**MANASQUAN PLANNING BOARD MEETING AGENDA
CONDUCTED WITH ZOOM
DECEMBER 14, 2021 4:00 PM – TUESDAY**

Re: Boro File No. MSPB-R1610
Variance – Cinfio
Block 185, Lot 14
337 Beachfront/336 First Avenue
R-4 Single-Family Residential Zone
Borough of Manasquan, Monmouth County, NJ

ALBERT D. YODAKIS, P.E., P.P.
PLANNING BOARD ENGINEER
BOROUGH OF MANASQUAN

PROPOSED DEVELOPMENT PLAN
SCALE 1"=10'

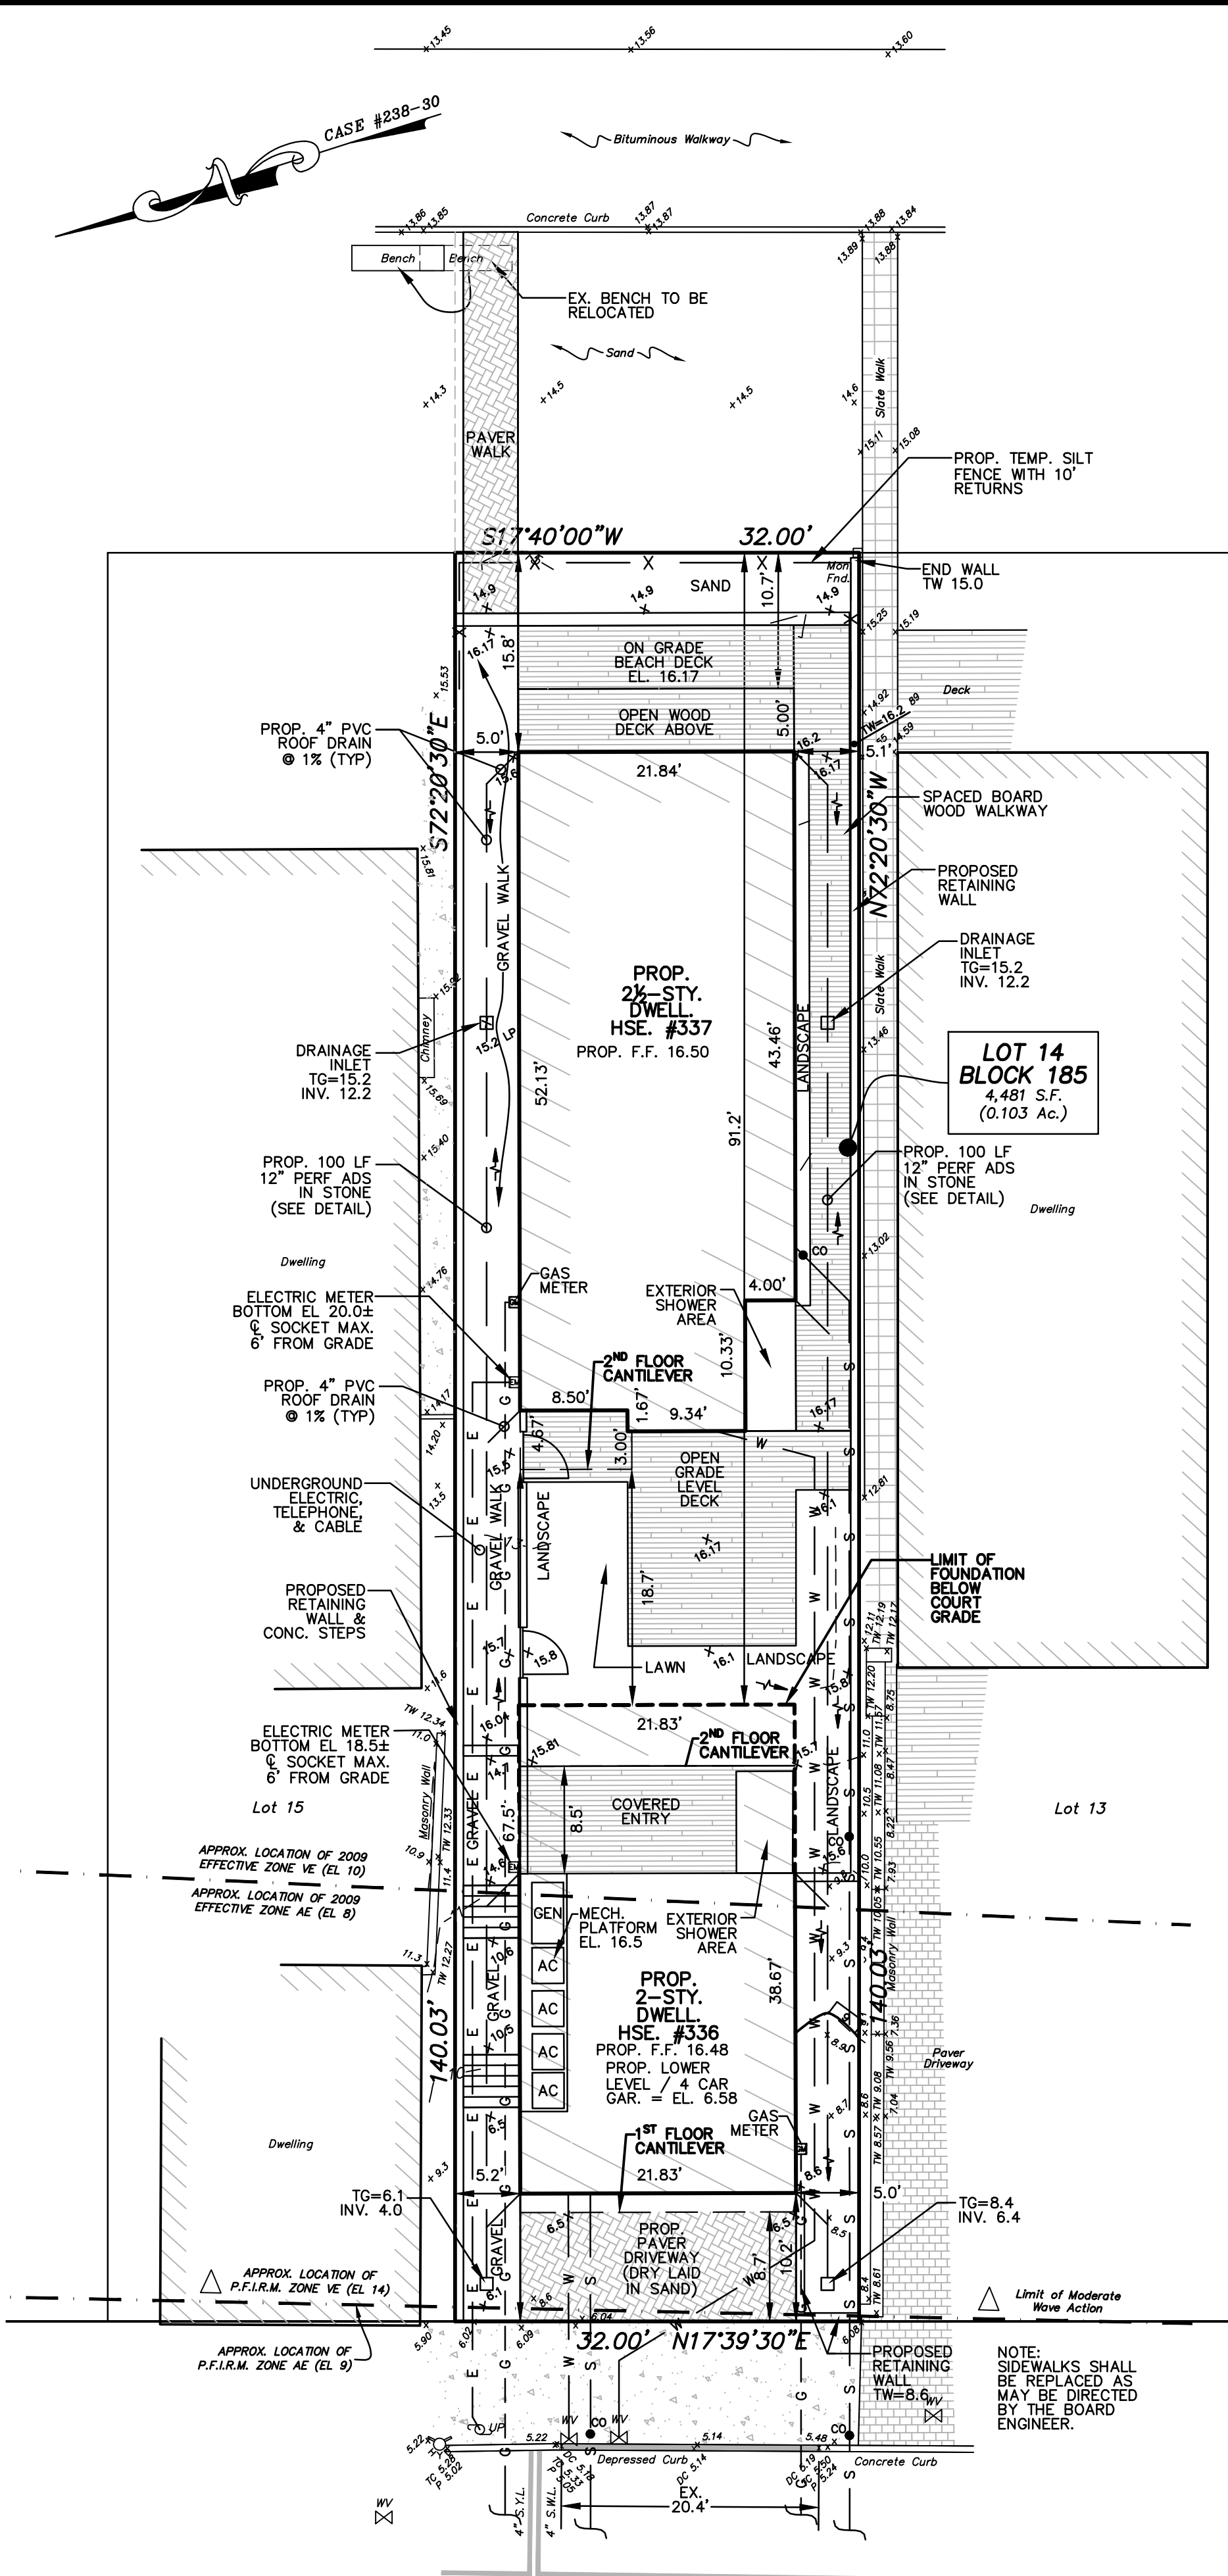
9. Construction details for the proposed retaining walls, concrete apron, and pavers should be provided on the plans.
 10. A landscaping plan for the property must be provided. No trees will be removed as part of this application.

PROPOSED DEVELOPMENT PLAN
SCALE 1"=10'

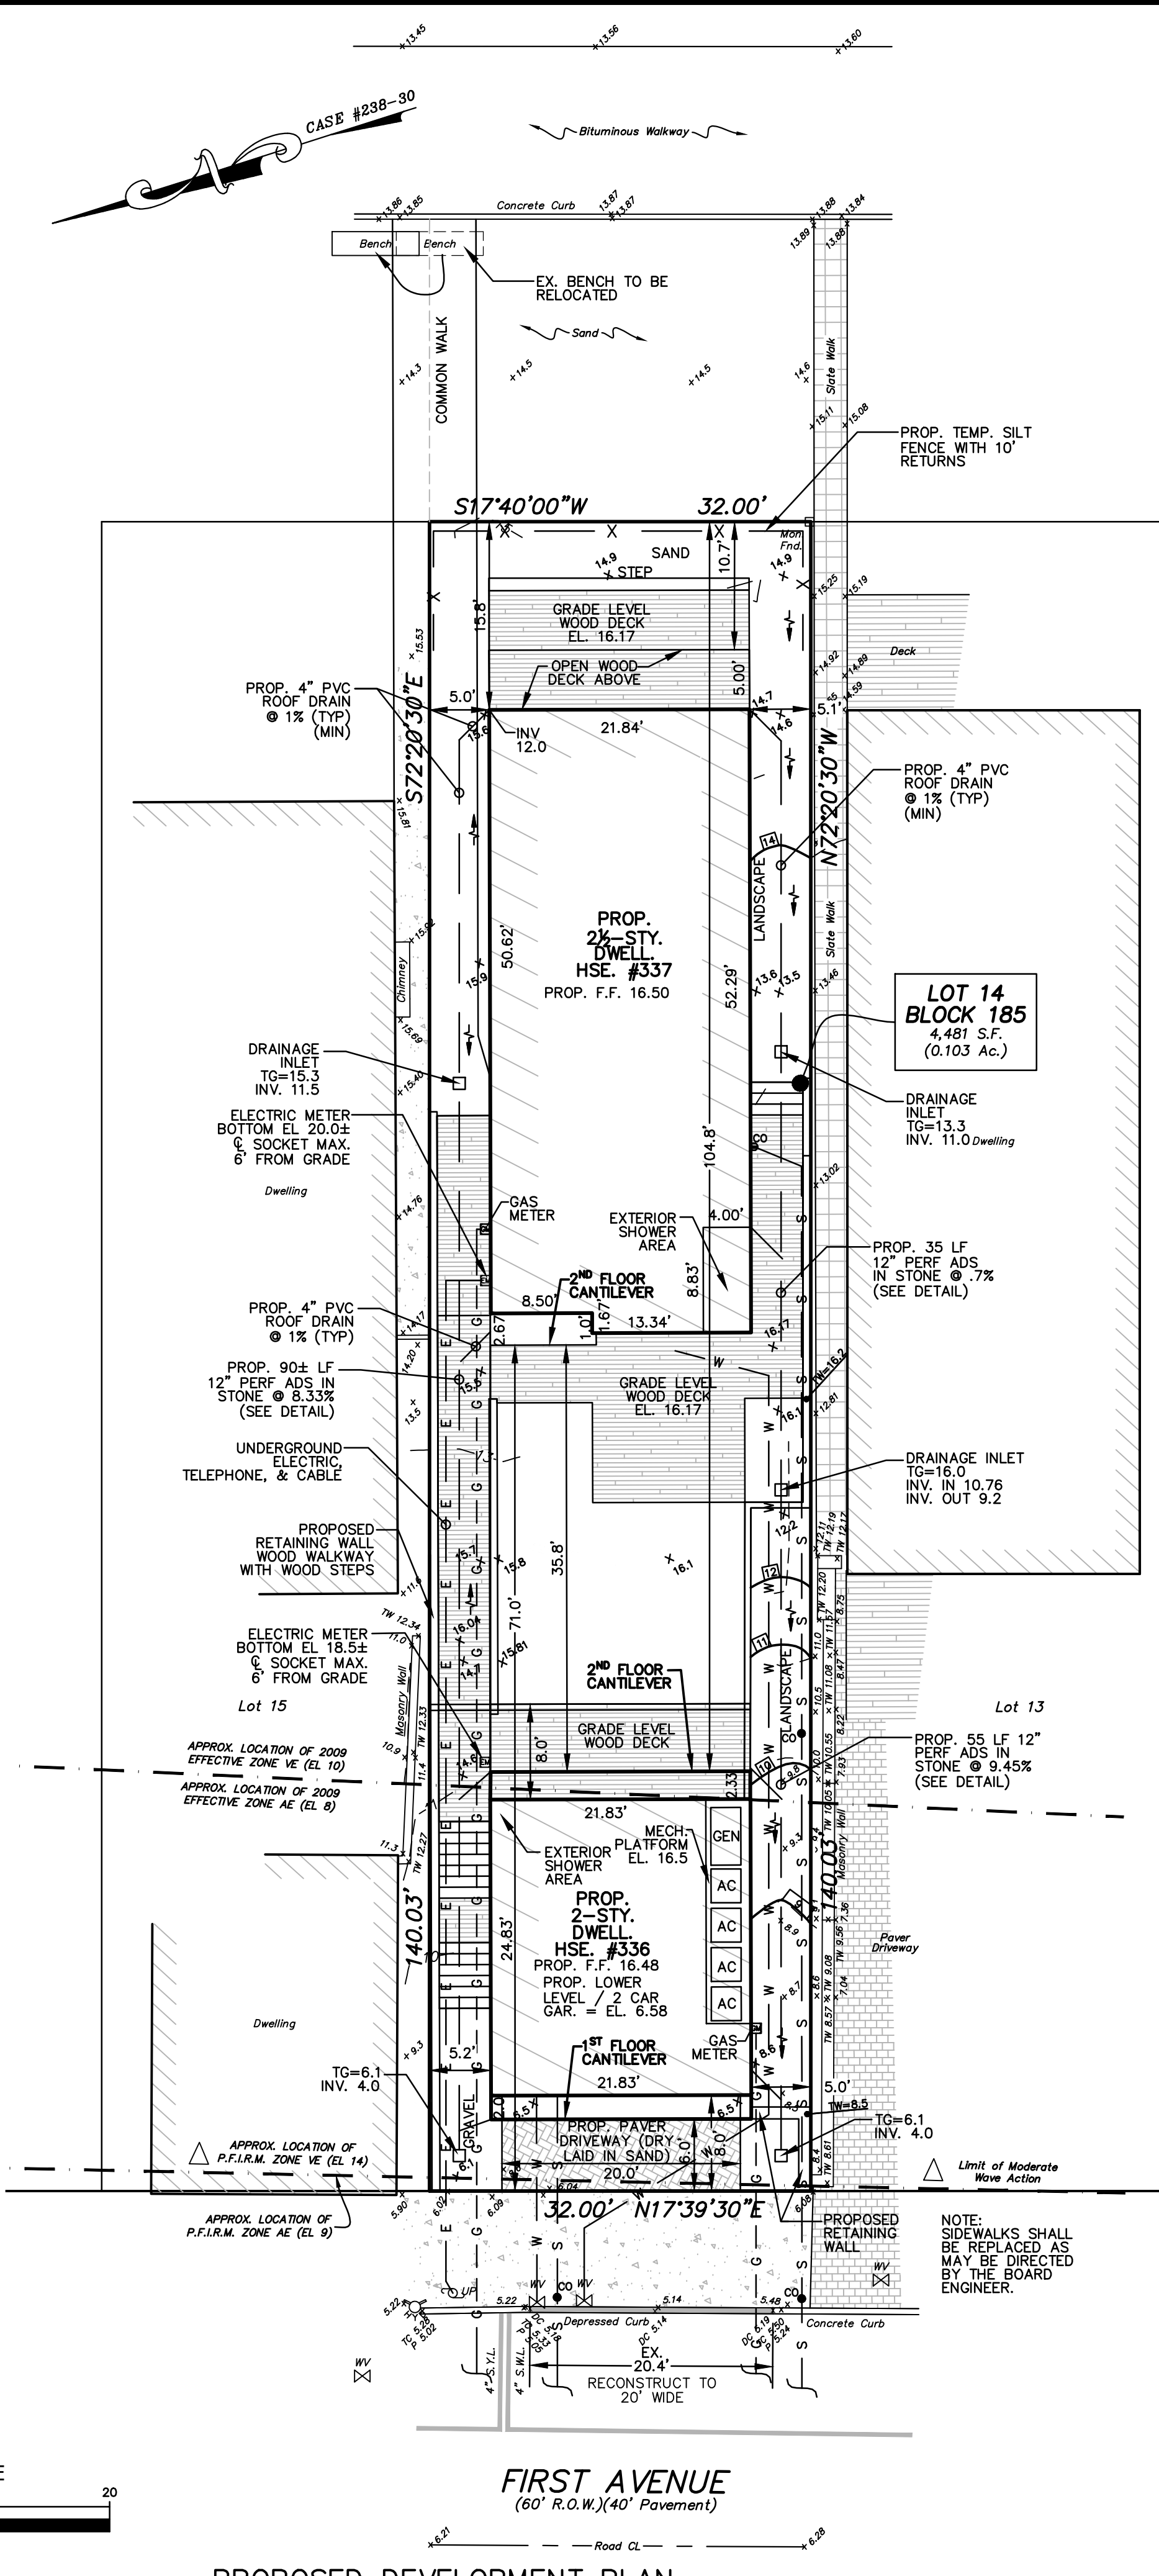
9. Construction details for the proposed retaining walls, concrete apron, and pavers should be provided on the plans.

10. A landscaping plan for the property must be provided. No trees will be removed as part of this application.
11. Any new utilities should be located underground if possible. The two dwellings are proposed to be serviced by separate water and sewer lines.
12. Any curb and sidewalk must be replaced along First Avenue as necessary.

PROPOSED DEVELOPMENT PLAN
SCALE 1"=10'

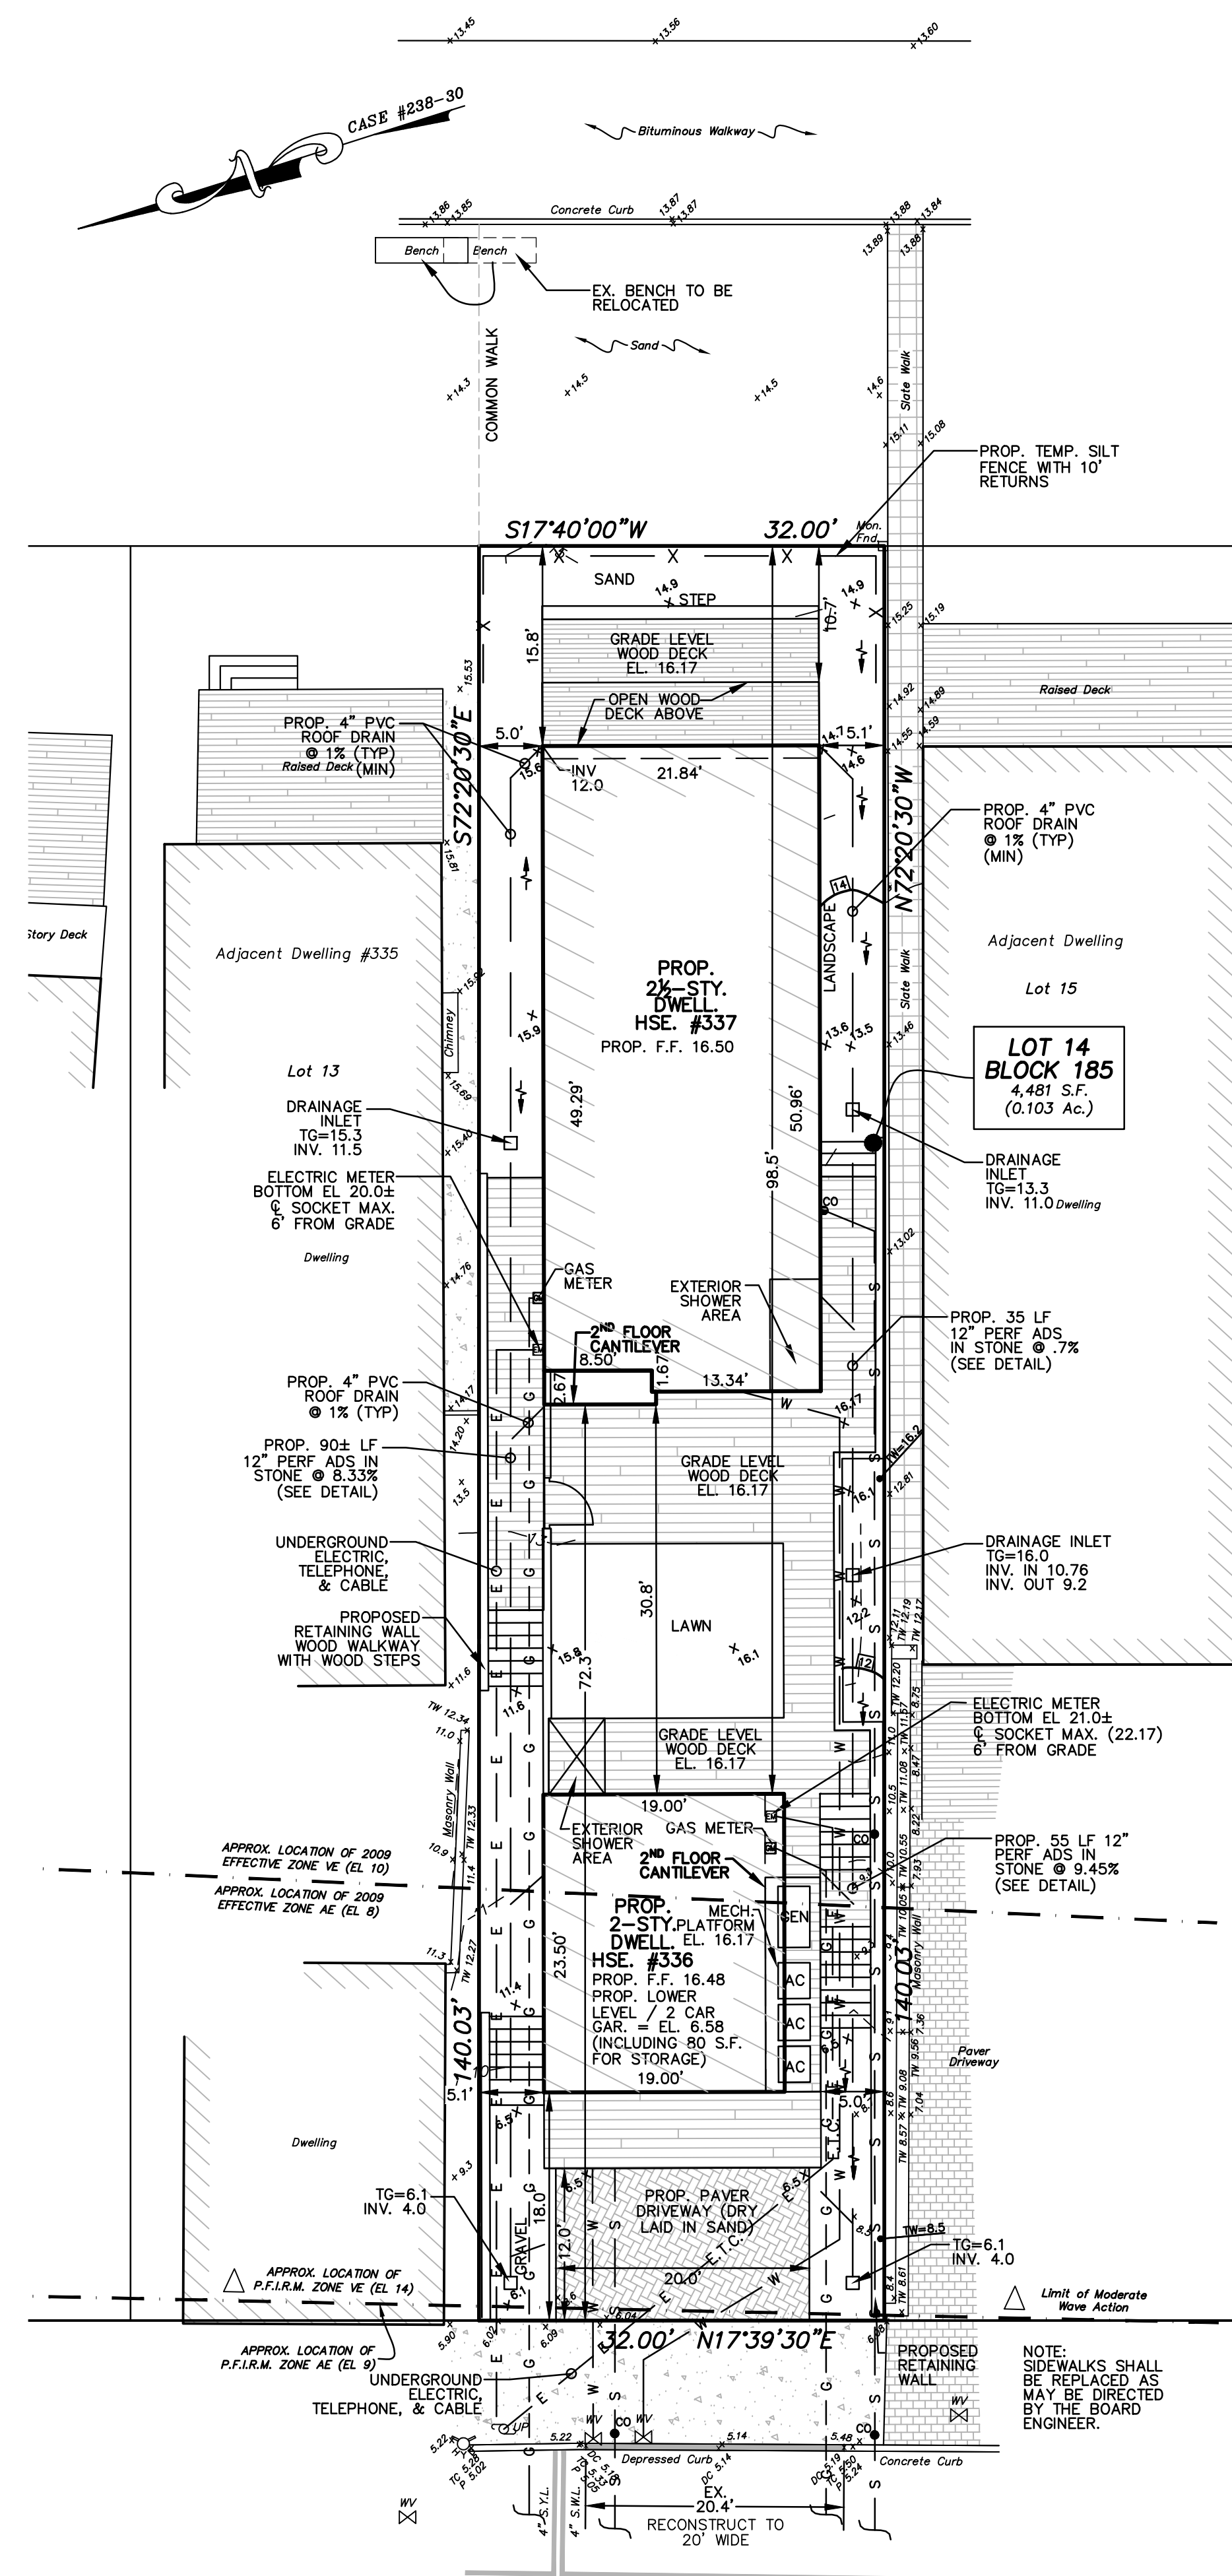
9. Construction details for the proposed retaining walls, concrete apron, and pavers should be provided on the plans.

10. A landscaping plan for the property must be provided. No trees will be removed as part of this application.
11. The two dwellings are proposed to be serviced by separate water and sewer lines.
12. Any curb and sidewalk must be replaced along First Avenue as necessary.
